CONSTRUCTION DOCUMENTS

FALCON MARKETPLACE

ISSUE	DATE
90% SUBMITTAL	5-6-19
REVISED	7-19-19
DESIGNED BY:	TDM
DRAWN BY:	KGV
CHECKED BY:	TDM
FILE NAME:	20988-CD-CVR

COVER SHEET

(1) POND #3 INFLOW AND OUTFLOW

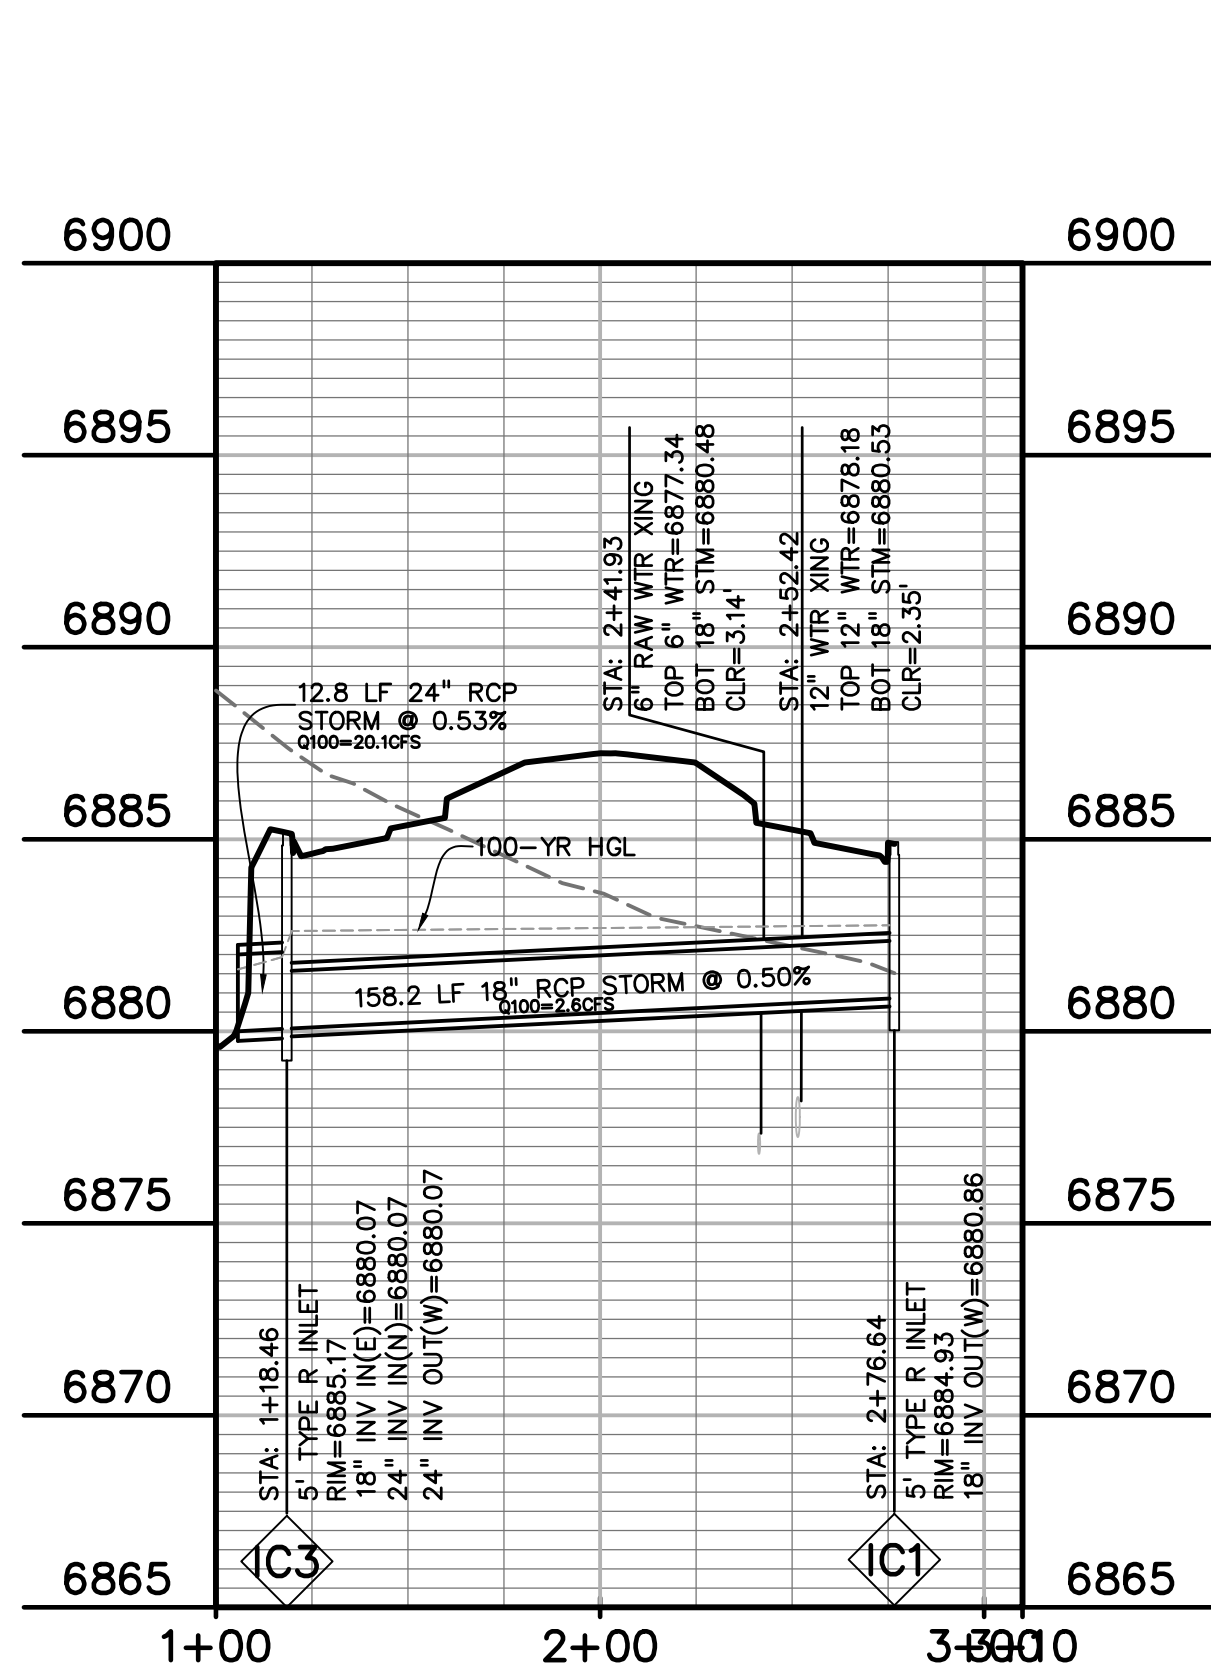
NOTE
ALL STORM SEWER TO BE PRIVATELY OWNED AND MAINTAINED
UNLESS OTHERWISE NOTED
Should #1 and #5 be public?

Show
headwater/ponding
depth.

STORM SEWER
PLAN &
PROFILE

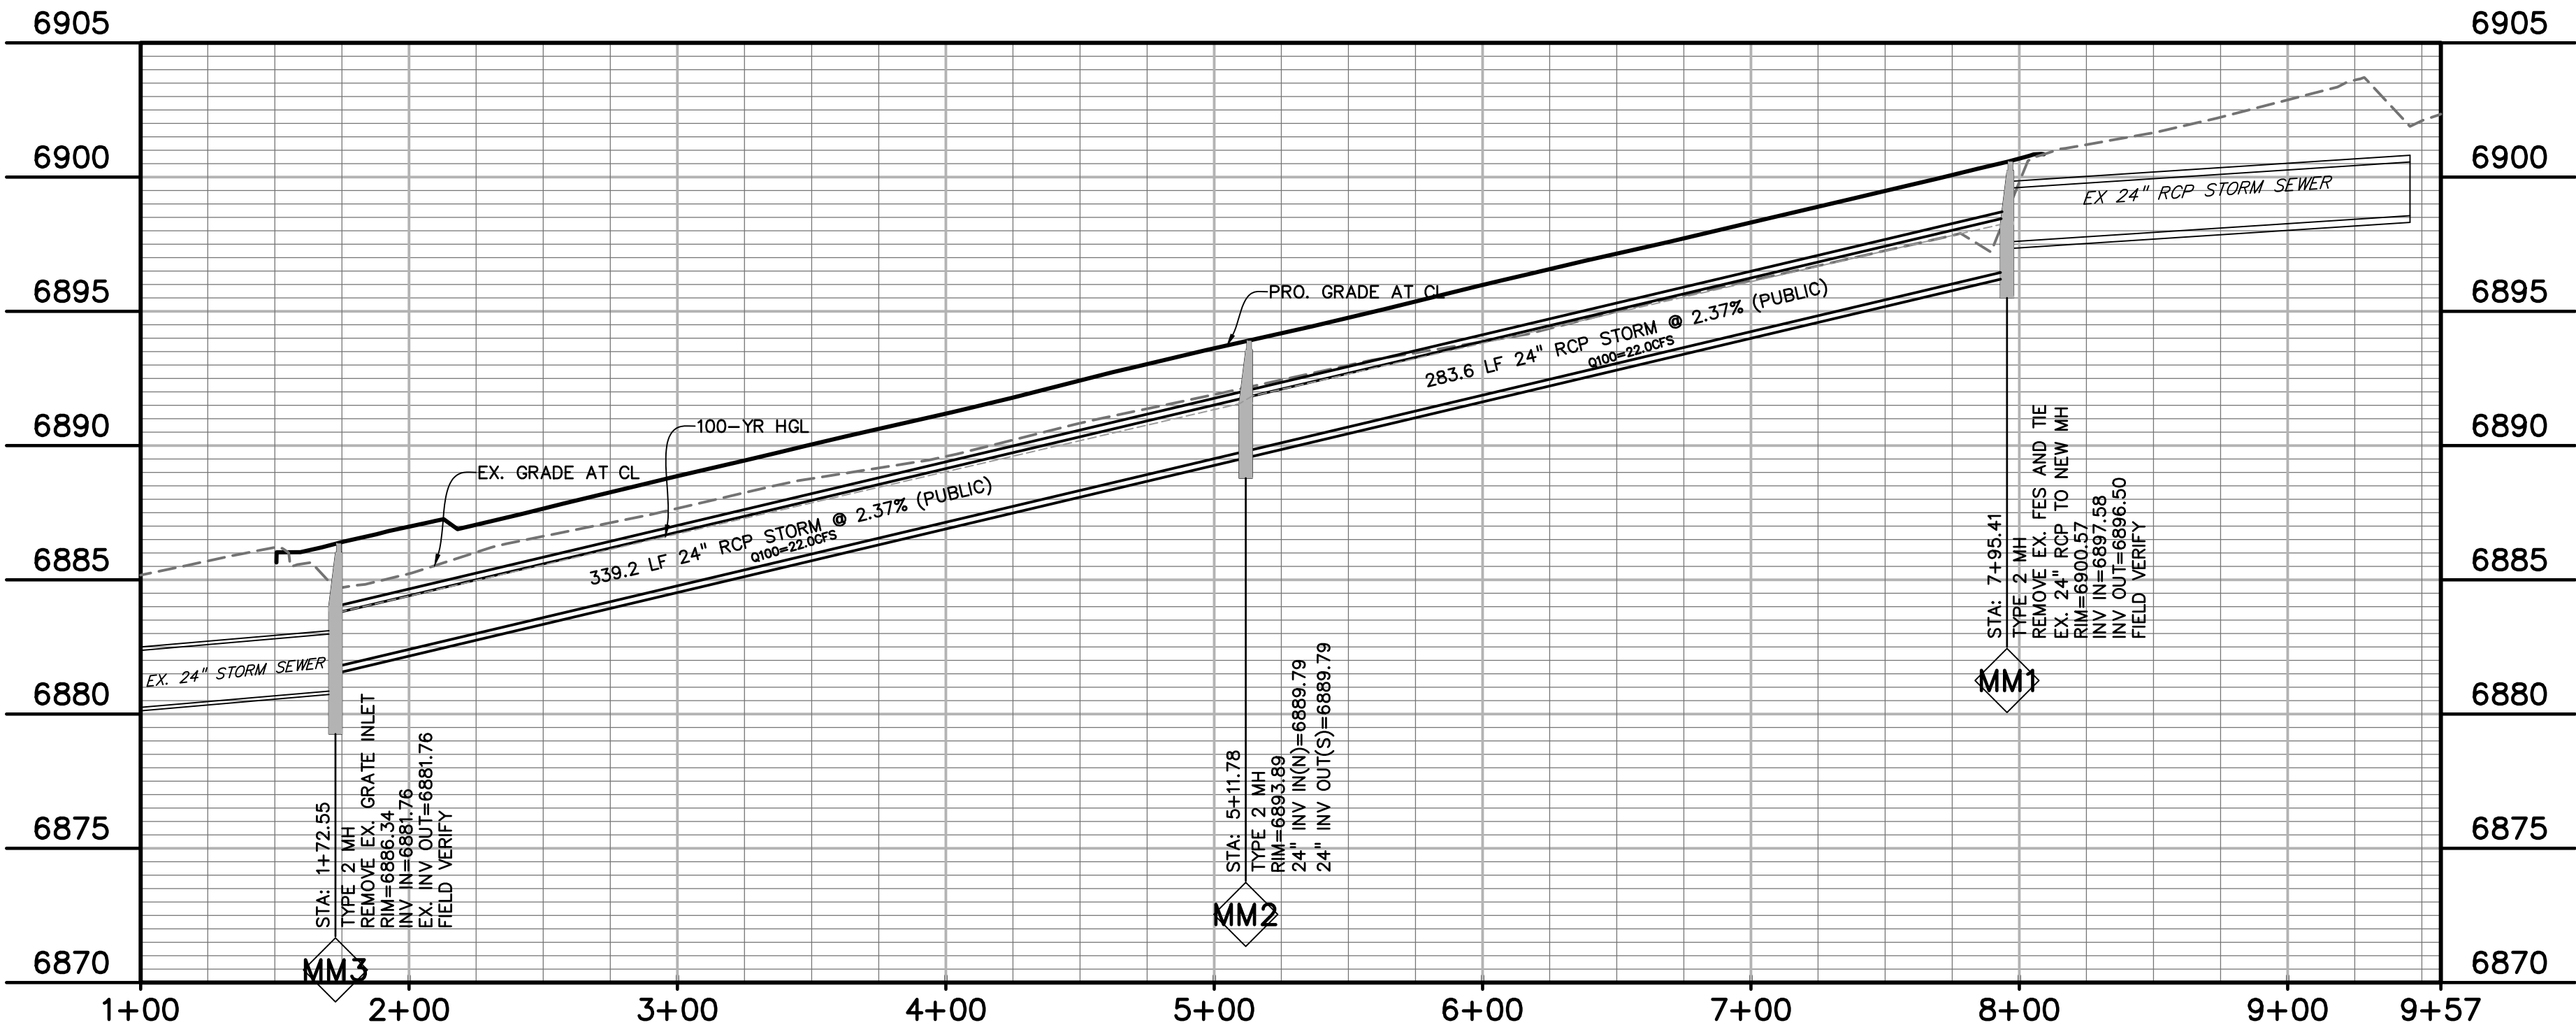
This pipe should be public

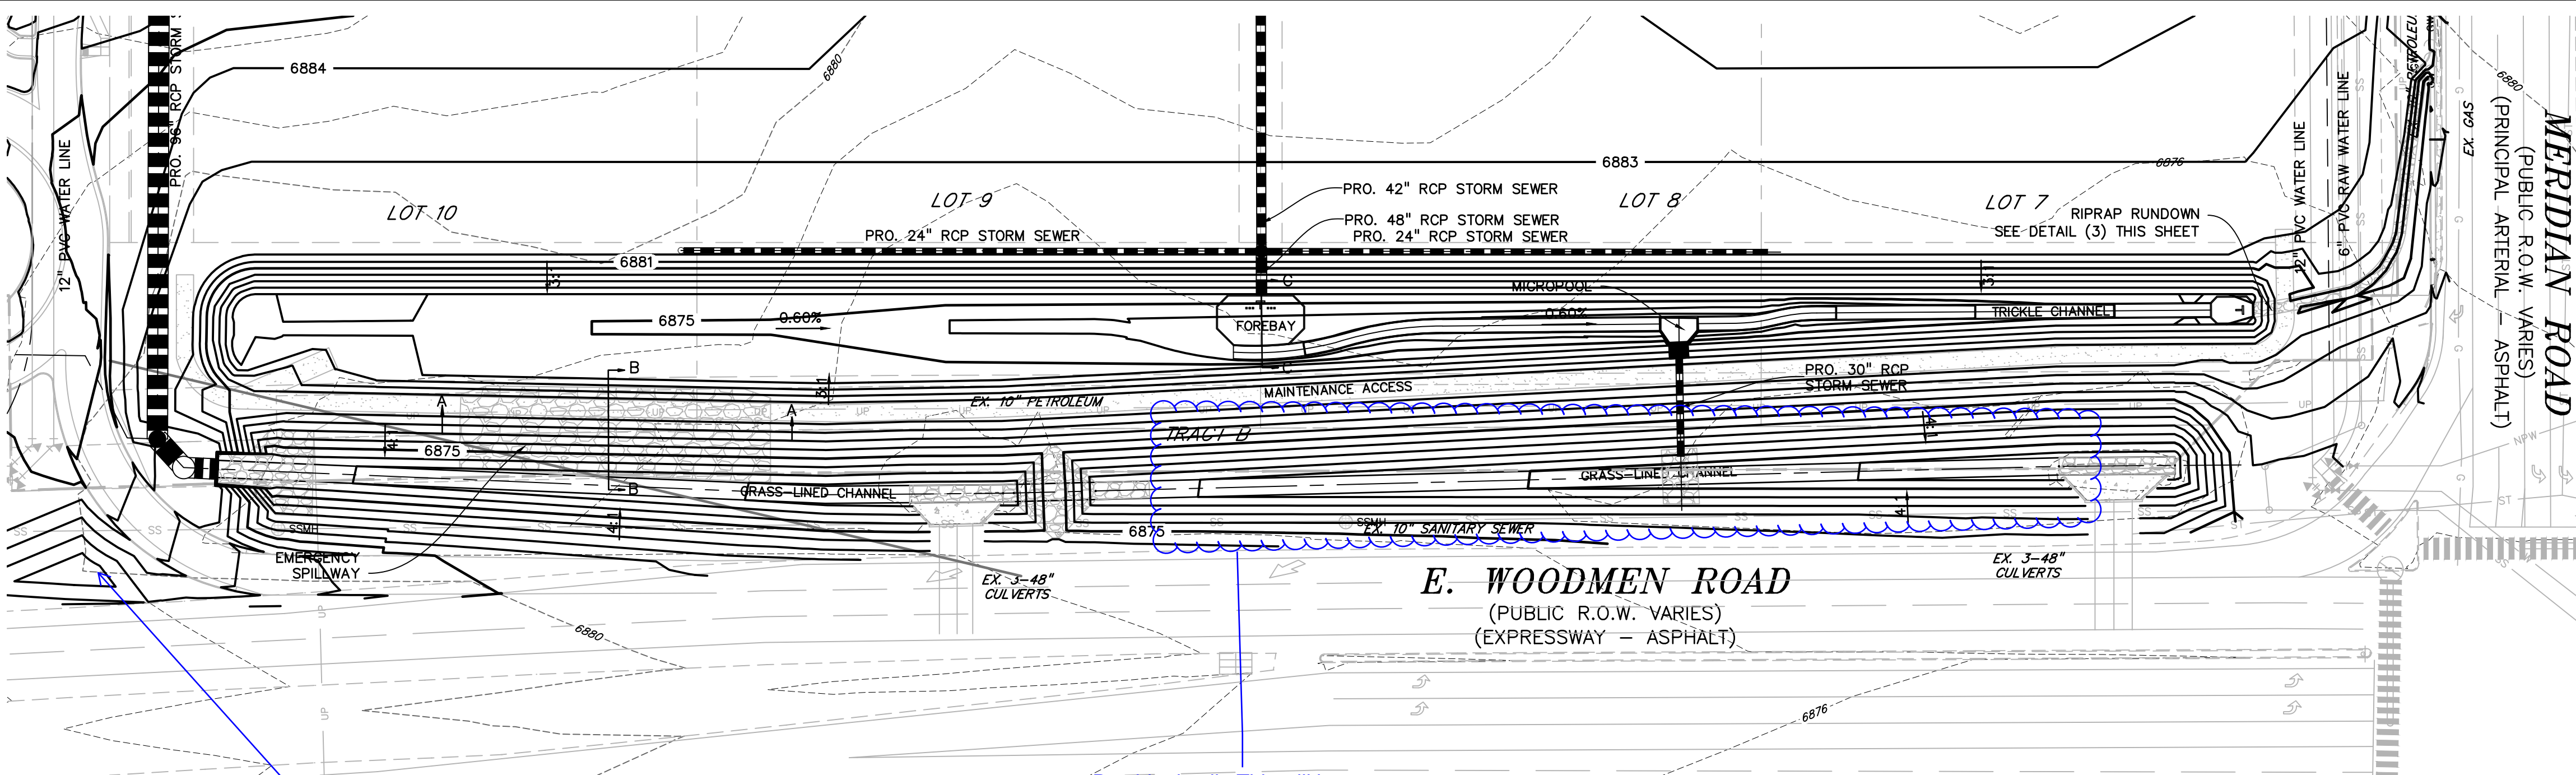
Show pipe...

Provide detail. This will be passing more than low flows, so it needs to be designed not to wash out.

Cross-sections, grades, erosion protection, etc.
